HORSHAM DISTRICT COUNCIL CONSULTATION

TO:	Horsham District Council – Planning Dept
LOCATION:	Land To The North and South of Mercer Road Warnham West Sussex
DESCRIPTION:	Redevelopment of the site to provide 304 residential units, parking, a retail unit, public car park, public open space, attenuation basins and landscaping
REFERENCE:	DC/25/0151
RE-CONSULT:	1 st set of comments in black 2 nd set of comments in blue
RECOMMENDATION:	Holding Objection / Modification Holding Objection / Modification
SUMMARY OF COMMENTS & RECOMMENDATION: 2nd set of comments While we acknowledge the submission of an updated LVIA, no substantive changes have been made to the proposed layout or landscape strategy. As such our holding objection is maintained. We continue to recommend that further consideration is given to the site layout and overarching landscape framework to ensure that landscape and visual effects are appropriately mitigated. In particular, we seek assurance that the rural and verdant qualities experienced on site and its surroundings is retained, and that the scheme is sensitively and successfully integrated into the receiving landscape. We encourage the applicant to explore opportunities

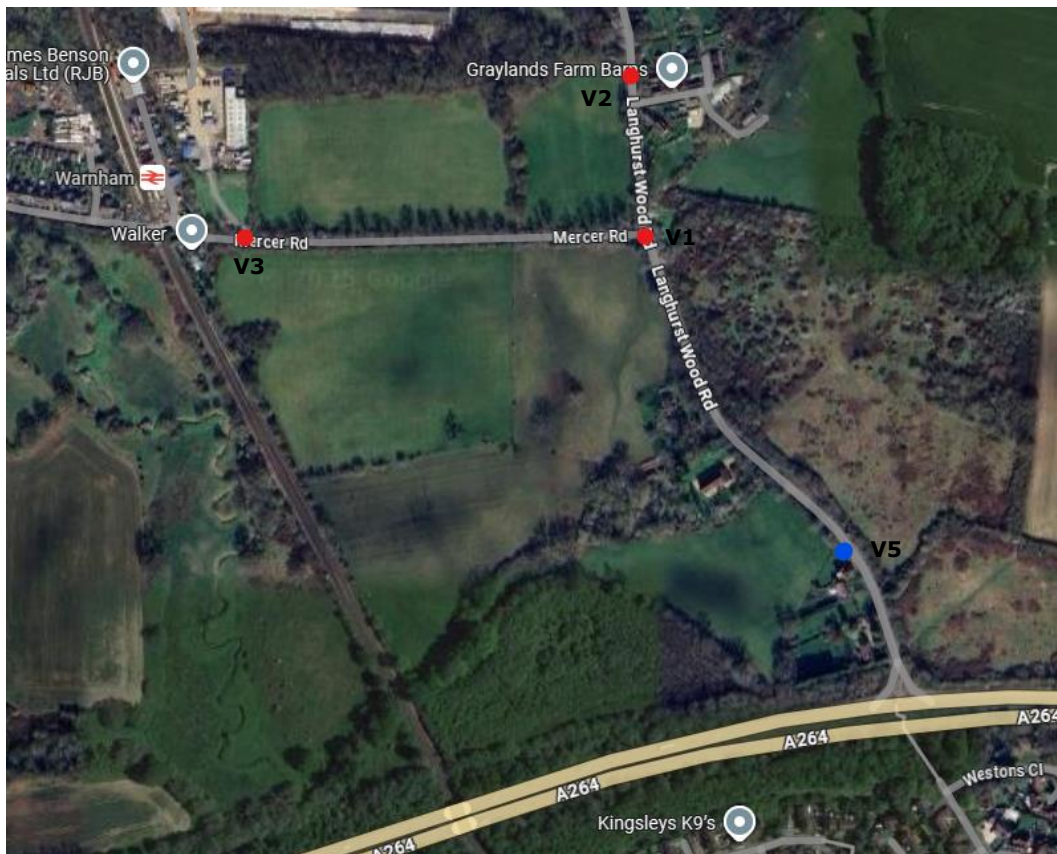
- V5: Adjusted to show more of the site as per the screenshot below. Please note that Type 3 visualisations are required for this viewpoint to illustrate the level of change.

The photograph and panorama below are taken from a site visit on 16th April 2025 and illustrates how open the site is and how the change will be significant with little in a way of mitigation proposed. The photomontages will help understand the level of effect and mitigation measures required to reduce this or effectiveness of the proposals.
